HISTORIC AND DESIGN REVIEW COMMISSION

November 15, 2017

HDRC CASE NO: 2017-306
ADDRESS: 420 BROADWAY
LEGAL DESCRIPTION: NCB 432 (SAN ANTONIO LIGHT), BLOCK 16 LOT 14
ZONING: FBZ T6-1, HS
CITY COUNCIL DIST.: 1
LANDMARK: San Antonio Light Building
APPLICANT: Adam Reed/Ford, Powell & Carson
OWNER: Graystreet, 420 Broadway LLC
TYPE OF WORK: Rehabilitation and exterior modifications
APPLICATION RECEIVED: October 27, 2017
60-DAY REVIEW December 26, 2017

The applicant is requesting a Certificate of Appropriateness for Phase 1 improvements to the property located at 420 Broadway which includes the following:

OHP RECOMMENDATION OF CONCEPTUAL APPROVAL W/ FOLLOWING STIPULATIONS:

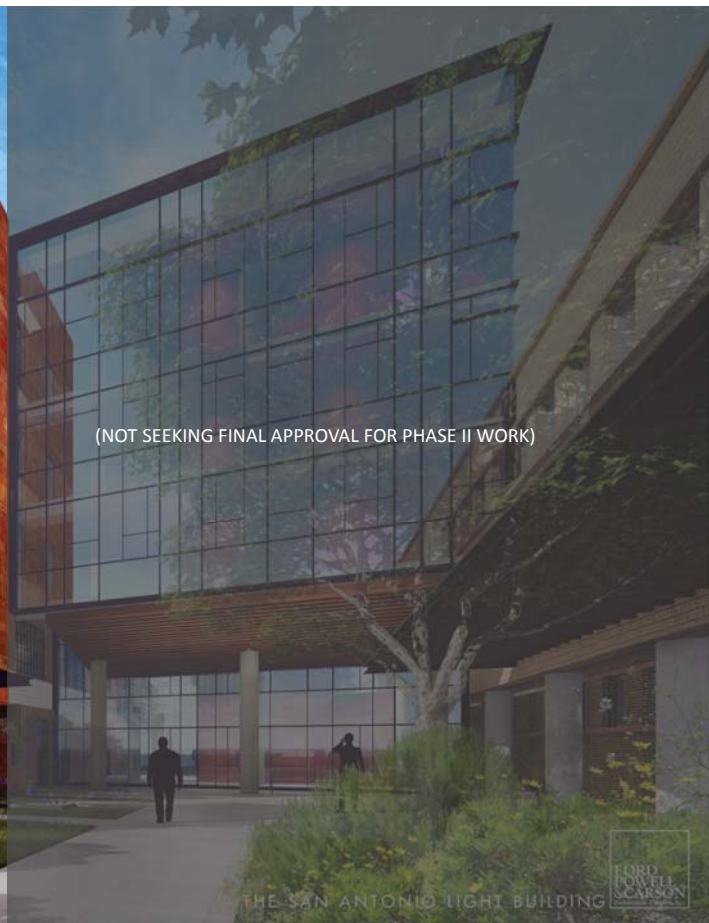
- Archaeology – Archaeological investigations are required. The archaeological scope of work should be submitted to the OHP archaeologists for review and approval prior to beginning field efforts. The development project shall comply with all federal, state, and local laws, rules, and regulations regarding archaeology.

- That the applicant remove the proposed solid cladding material proposed on the connector addition and incorporate glazing as noted in the early conceptual sketch included in the application documents as noted in finding e.

- Archaeology – Understood. This will be confirmed and included in the scope of work.
- That the applicant remove the proposed corner tower and maintain the existing last column bay as is as noted in finding h.

- Vertical Connector (*to be submitted for Final Approval at a later date once design and programming decisions are confirmed*) massing will be minimized by introduction of more glazing as per the original conceptual sketch. The double height 1st Floor steps back for more delicate visual impact on the historic Light Building. Visibility through the connector will be maximized via more glazing.
